UNITED STATES PATENT AND TRADEMARK OFFICE

APPLICATION NO.	FILING DATE	FIRST NAMED INVENTOR	ATTORNEY DOCKET NO.	CONFIRMATION NO.
09/473,315	12/28/1999	LARRY EUGENE MOSLEY	884.209US1	9830

# Office Action Summary

## DETAILED ACTION

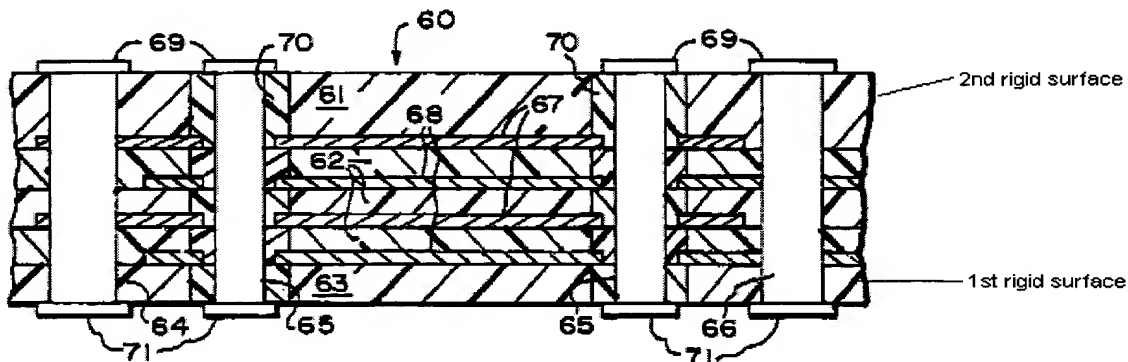
Regarding claim 9, Farooq et al. disclose in fig. 3 A, a multilayer capacitor having a pair of outer surfaces (see below), and a number of pads (69) located on two of the number of outer surfaces; wherein two of the number of pads are capable of being coupled to a substrate using a solder bump. Although Farooq et al. do not expressly state that the outer surfaces are "substantially rigid"; it is an inherent feature of the capacitor of Farooq et al. (see method of forming the capacitor – a fired ceramic green sheet produces a "substantially" rigid surface).

Regarding claim 10, the multilayer capacitor includes a number of parallel conductive layers and the number of pads coupled to the number of parallel conductive layers through vias.
